DRAFT Preliminary Review: Navy Groundwater Flow Model for the Navy Red Hill Facility

The Department of Health Hawaii (DOH)

May 10, 2021

GW Elevation Variance – Transient Models

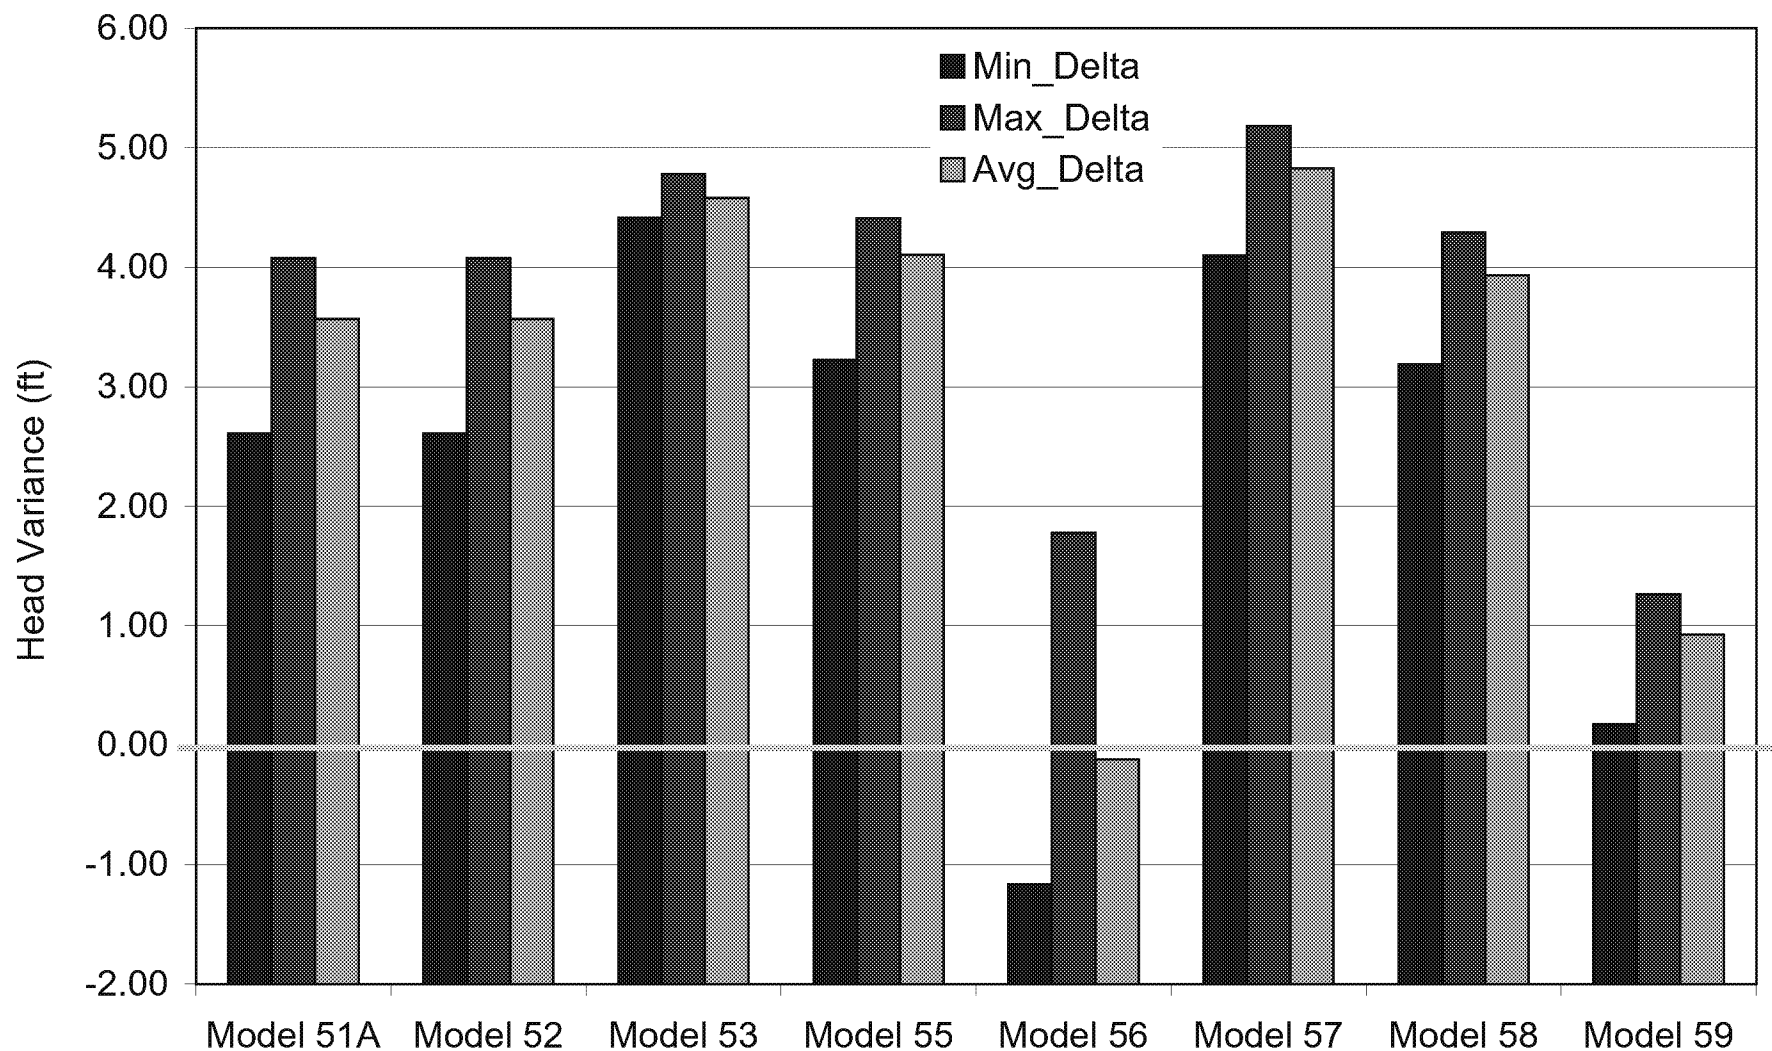
The Primary Issue with Prior Model (*calibrated to drawdown, but not to heads; complexity*)

Modeled Groundwater Elevations Compared to Actual Synoptic Data
Verification Model Variances to Measured Red Hill Area Well

Well Response Differs in Various Wells

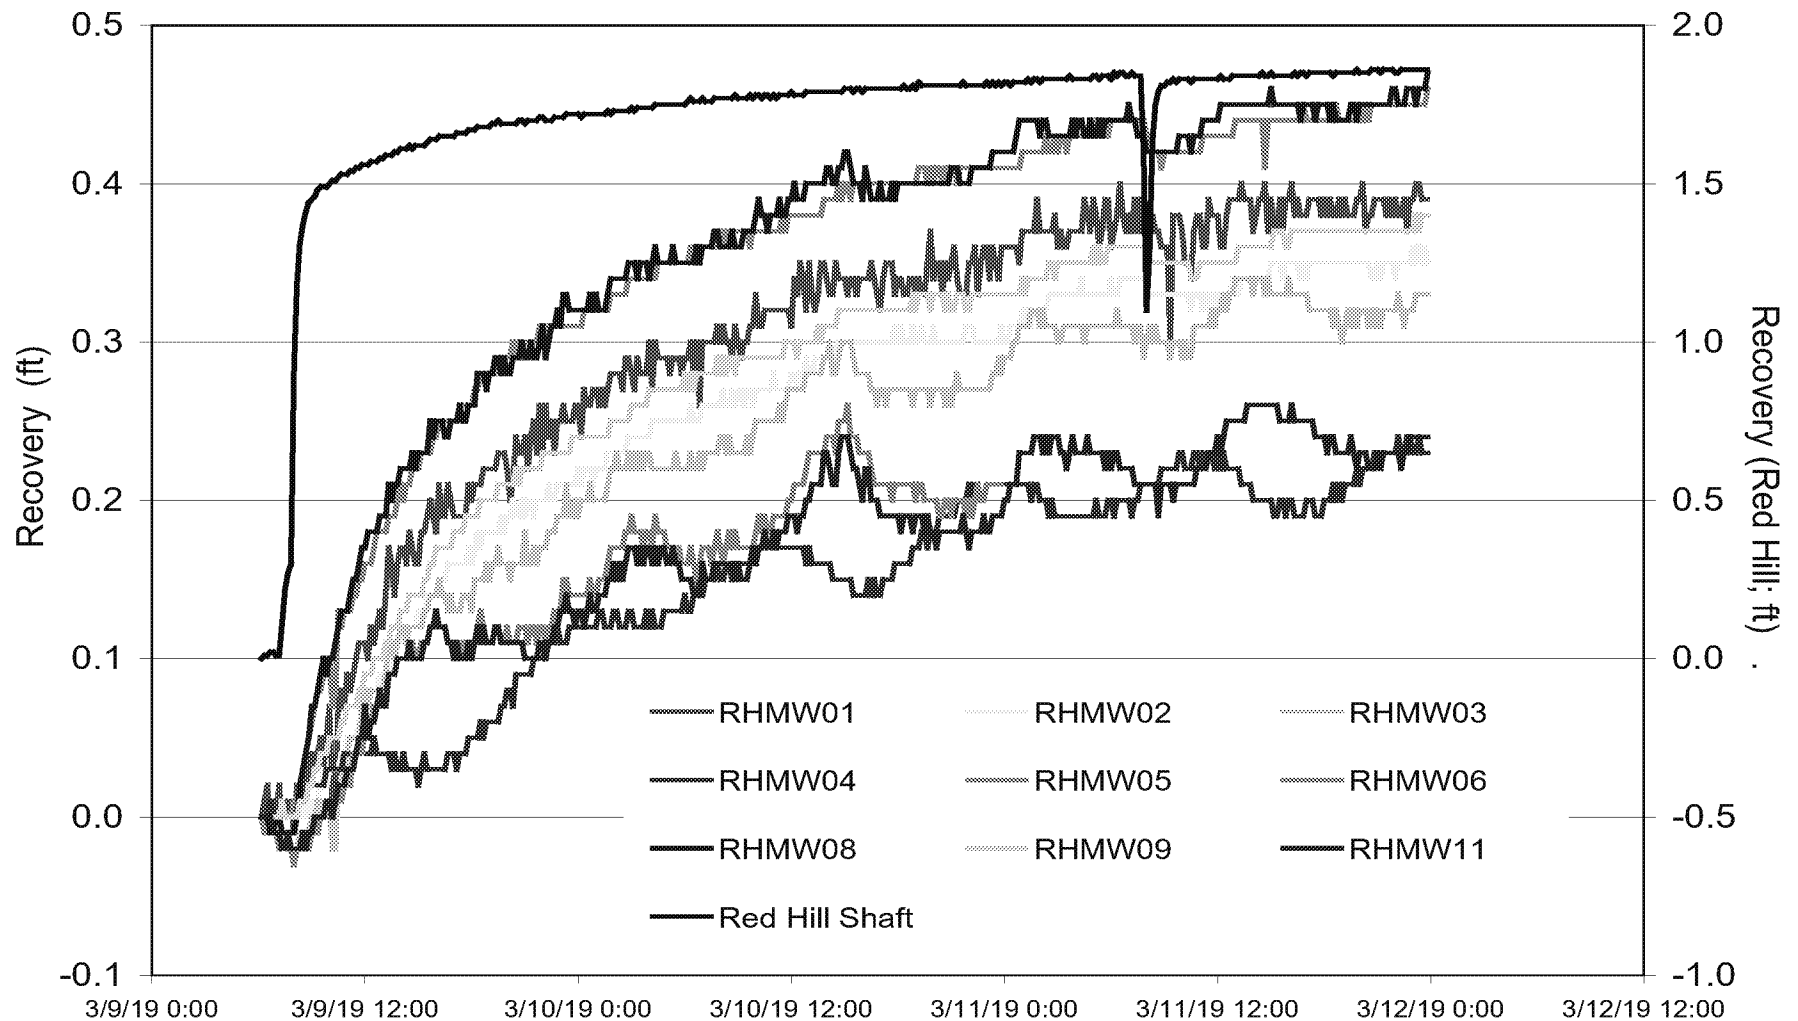
Water Level Recovery Hydrograph: Red Hill Well Series

Modeled Gradients Are Too Large

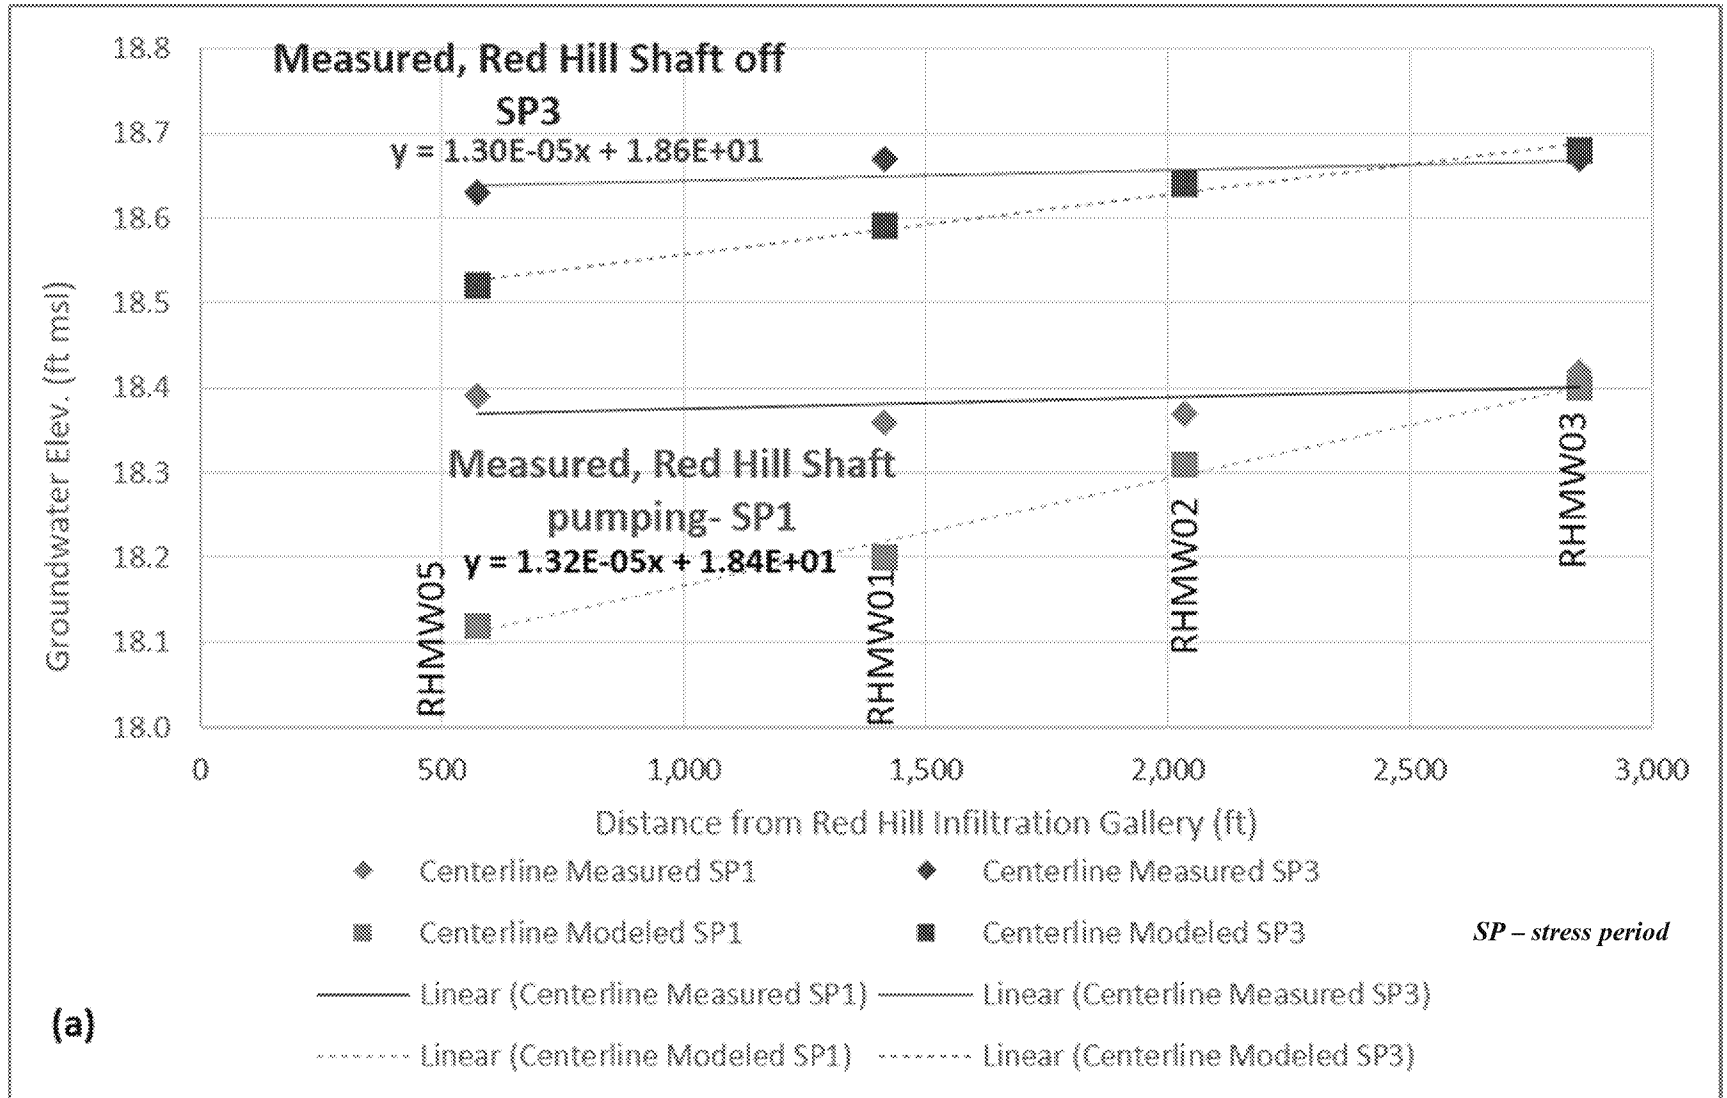
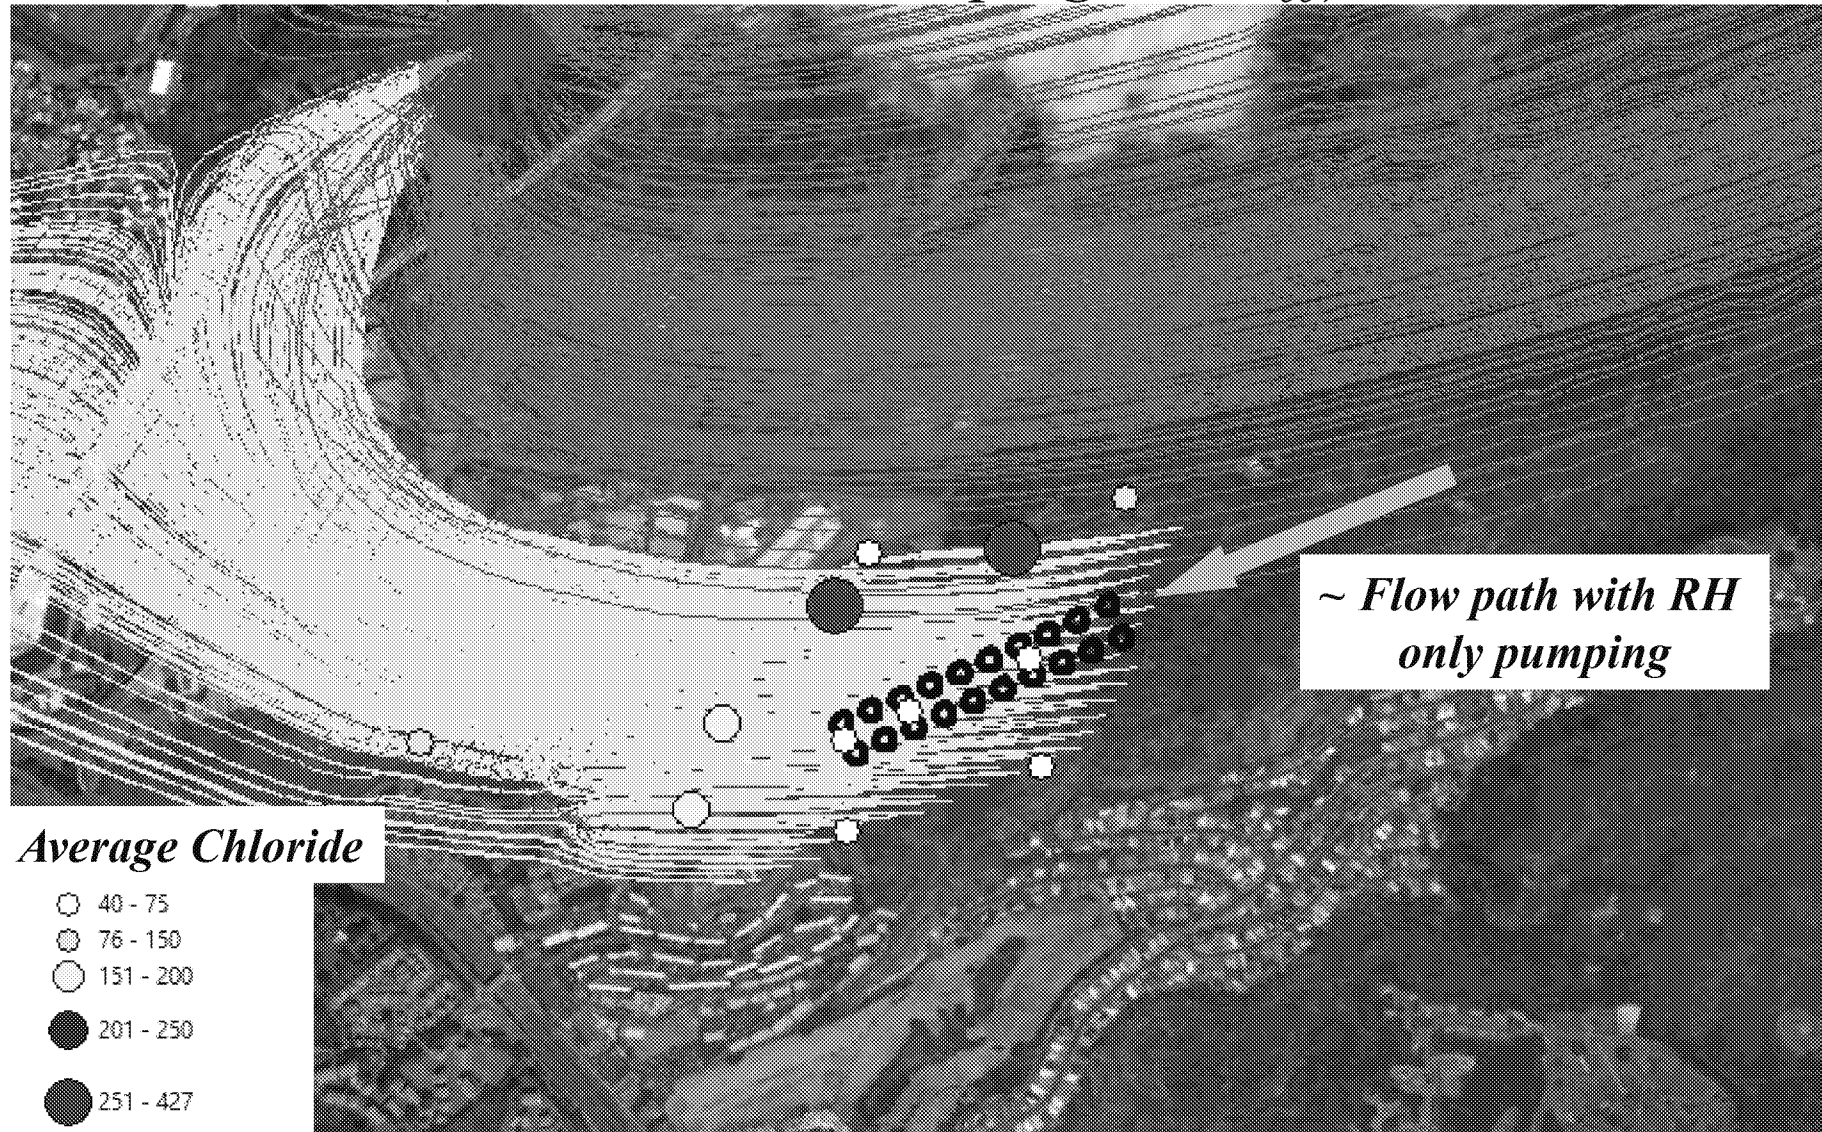
(Red Hill area, no gradient change under pumping)

Unit Source Contributions to RHS

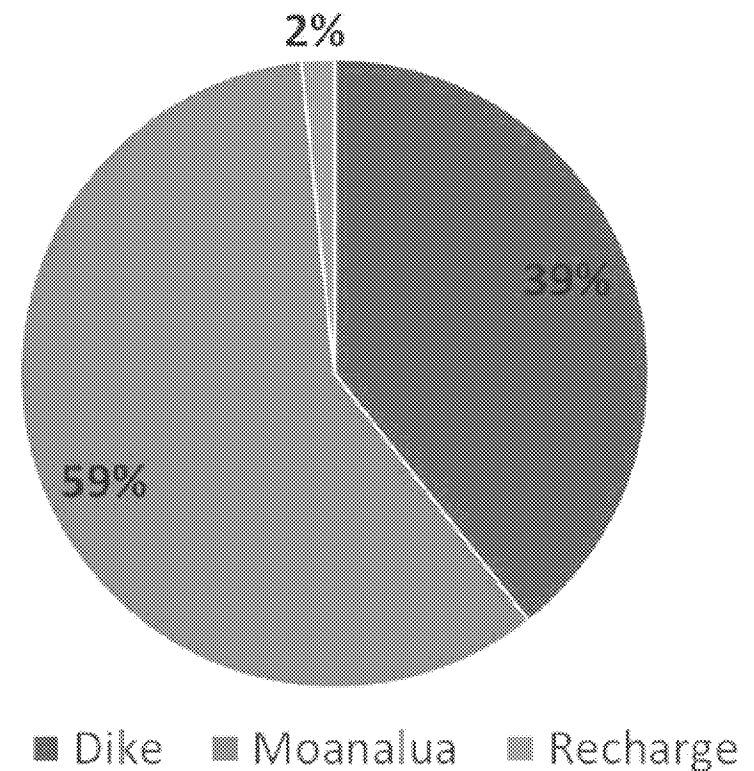
- “Unit source” mixing suggests contributions to RHS of the various sources of water as shown
- This scenario / graphic does not break out “upwelling” as a source at this time
- In this scenario, inflow from Moanalua is dominant: this results from efforts to match the apparent WNW gradient direction indicated by water level data

Chloride Distribution

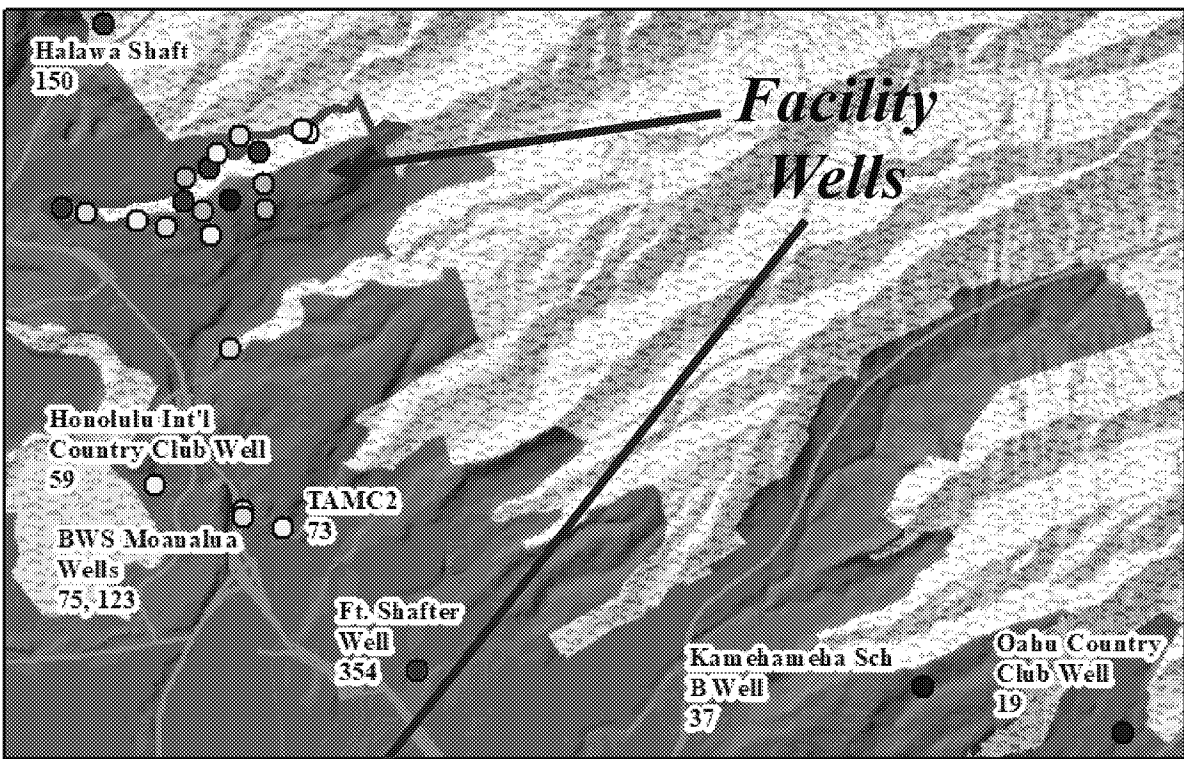
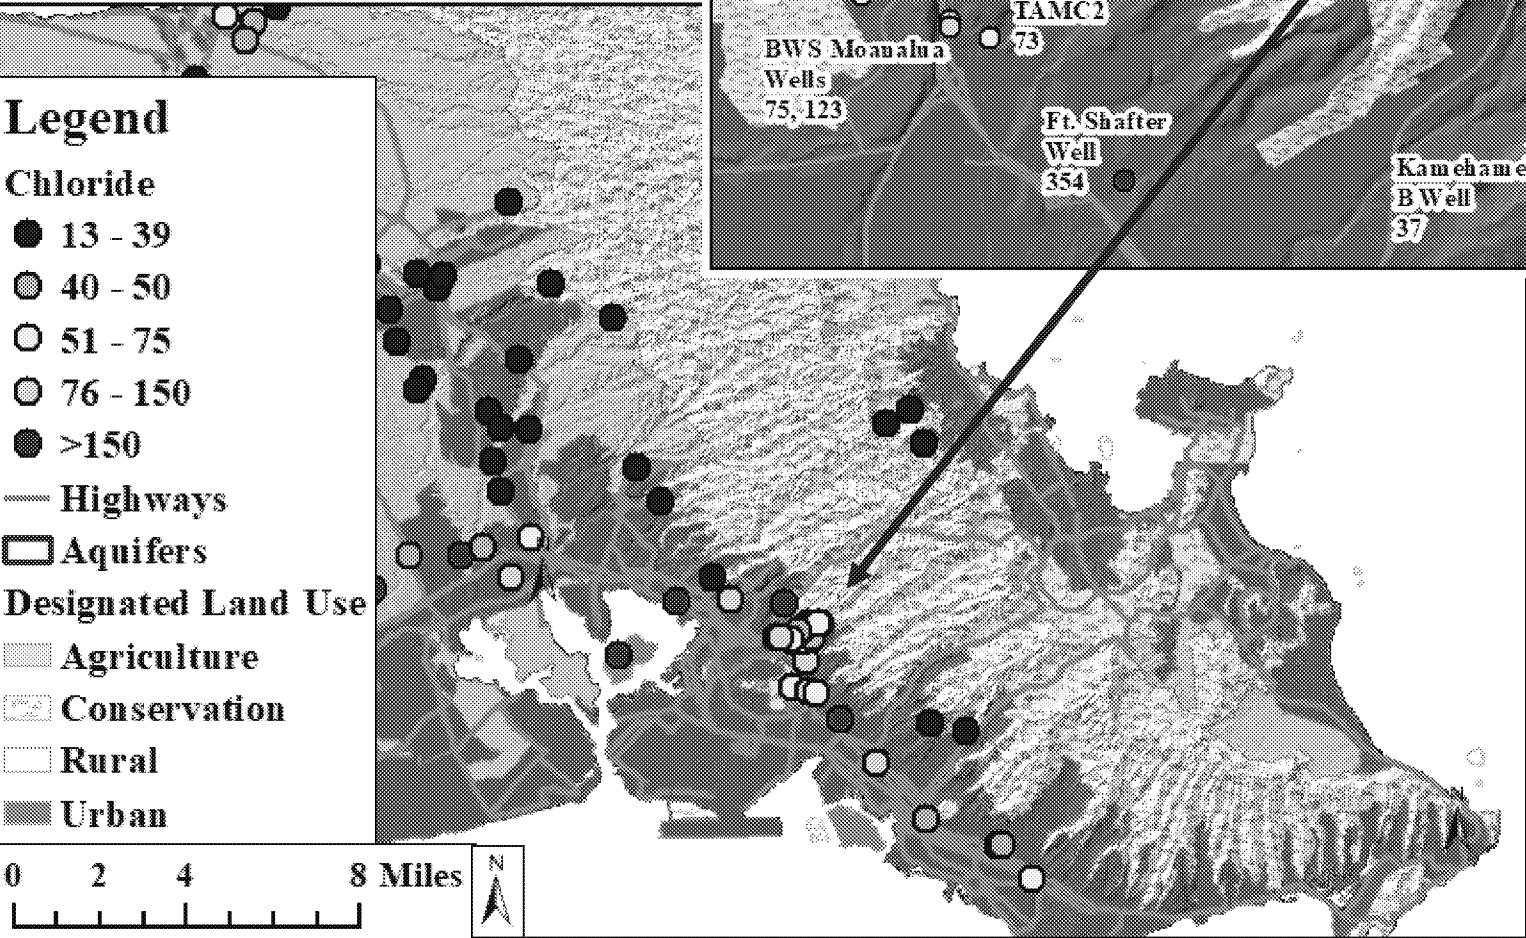
- *Rift Zone Recharge Areas*
 - ≤ 30 mg/L
- *Moanalua production wells*
 - ~65-123 mg/L (average 80 mg/L)
- *Contrasting Chloride concentrations can be used to validate or refute model results*
